**Design Review Committee**  
**January 12, 2012**

**SUBJECT:** **Case 17442, Substantive Site Plan Approval – Citadel Hotel  
Redevelopment, 1960 Brunswick Street**

1. Approve the qualitative elements of the substantive site plan approval application for the mixed-use redevelopment of the Citadel hotel site at 1960 Brunswick Street, as shown on Attachment A; and
2. Approve the requested streetwall height variance along Brunswick and Cogswell Streets as shown and described on Attachments A and B.

Image 1 - Channelling Effect

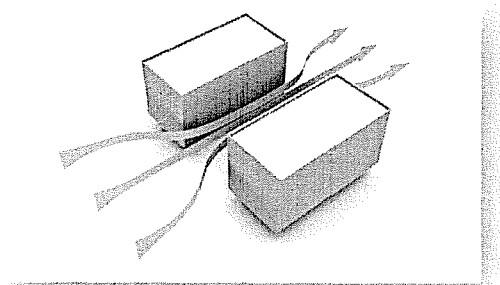
Winds at Locations 23 through 25 were caused by the predominant north-westerly winds in the winter. These winds accelerated along Brunswick Street, between the buildings; this is referred to as a Channelling Effect (see Image 1), and although it contributes to stronger winds in the area of the proposed Apartment building, wind conditions in the area were similar to the existing conditions.

To improve wind conditions in these areas, the architects have included interior vestibules and recessed entrances (approximately 1.5m recess). While the recess is not significant enough to provide ample shelter from the winter winds, the inclusion of a

Image 2 - Glass Parapet or Wind Screen

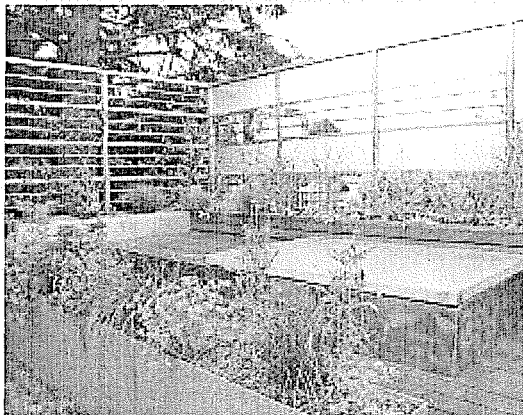
Ideally, sitting conditions are desired for terraces in the summer. During the summer, wind conditions on the upper terrace (Location 58) were comfortable for sitting, whereas wind conditions on the lower podium terrace (Locations 56 and 57) were comfortable for standing (Figure 3b). These wind speeds were due to south-westerly winds channelling between the two hotel towers (see Image 1). We understand the lower terrace will be a green roof and will include some landscaping, which along with the canopy/trellis feature extending between the towers is a positive feature that will help to shelter the area. However, if lower wind speeds are desired, we suggest including wind screens (at least 70% closed) or dense landscaping (minimum 2.5m in height) along the entire west edge of the podium (see examples in Images 2a and 2b).

Drawn by: GDA	Figure: 4b
Approx Scale: 1:1000	
Date Revised: Oct. 25, 2011

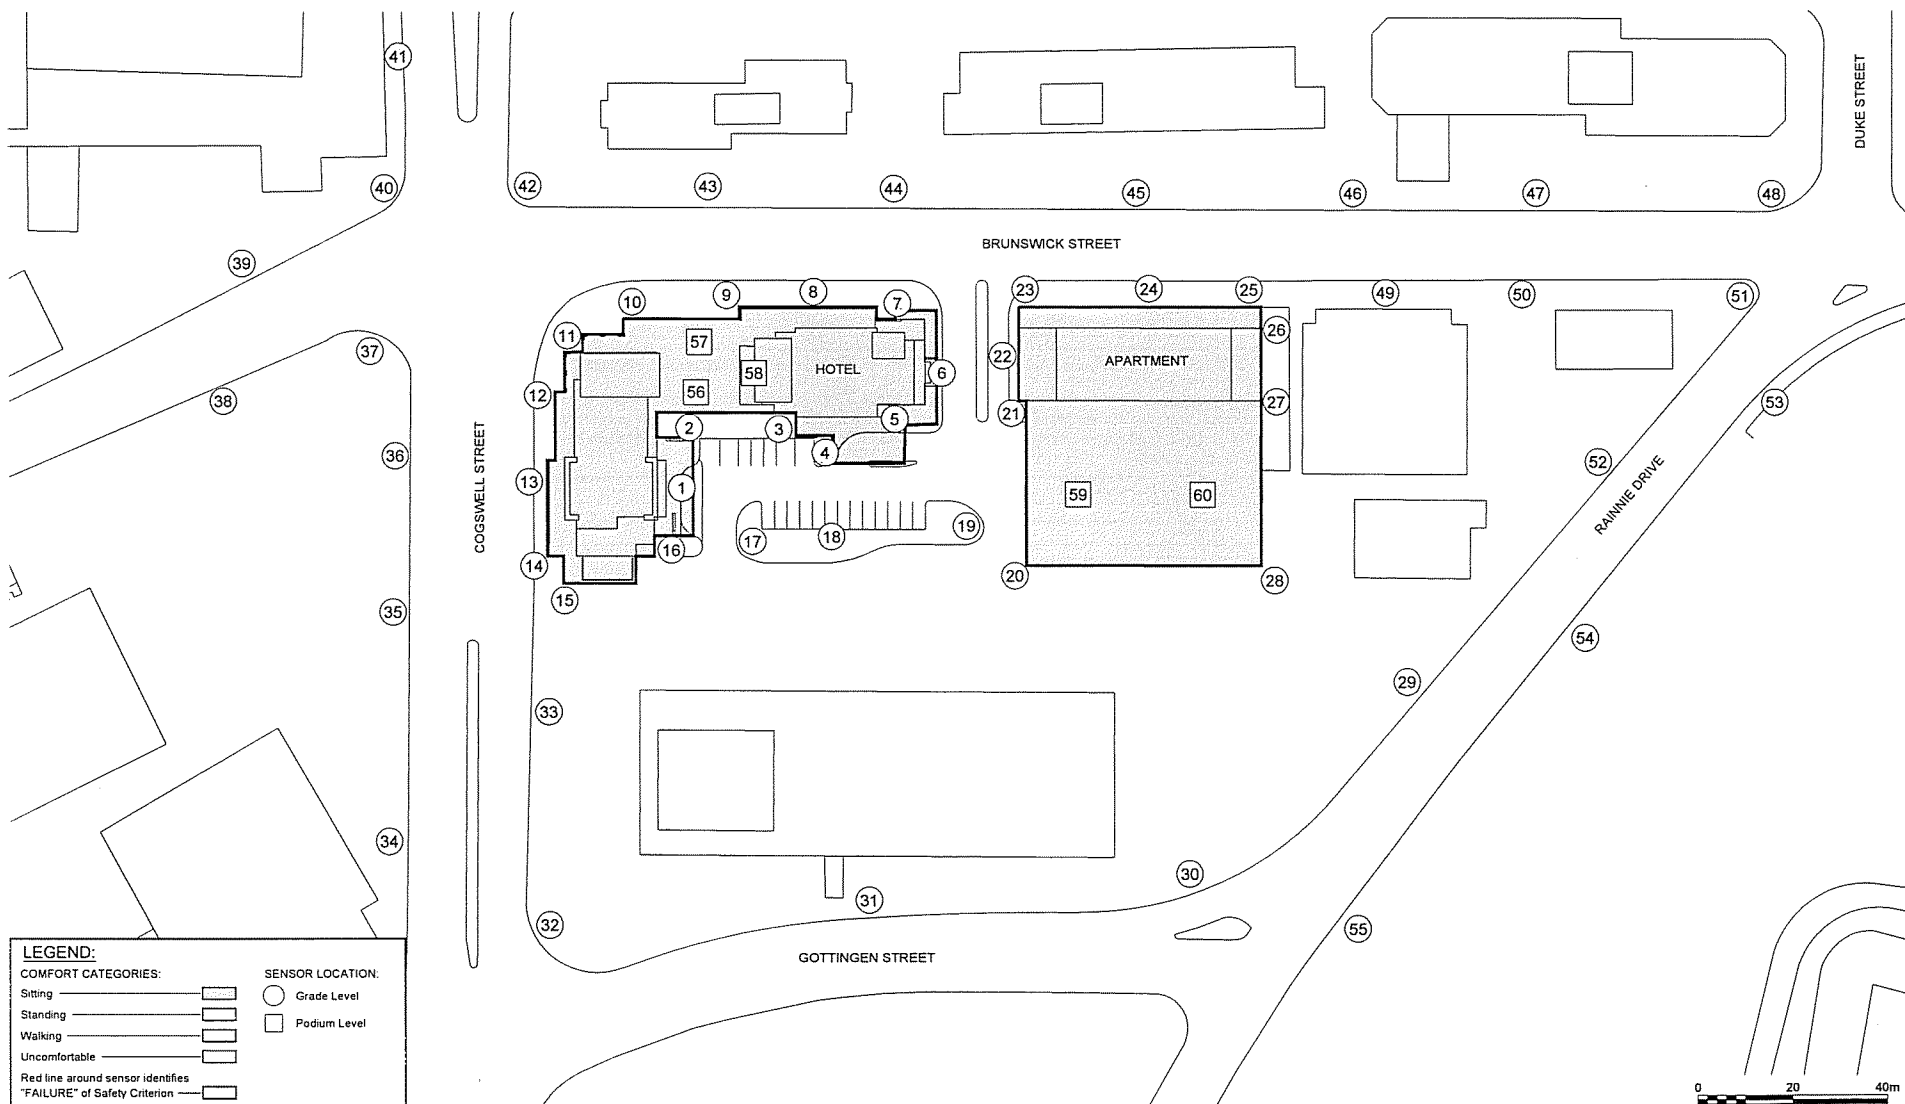
Wind conditions suitable for walking were observed at the key-card access door (Location 14) and at the retail entrances (Locations 10 and 11) in the winter (Figure 4b). If lower winds speeds are desired at these entrances the design team could consider including vestibules or recessed entrances, to provide more protection from prevailing winds.
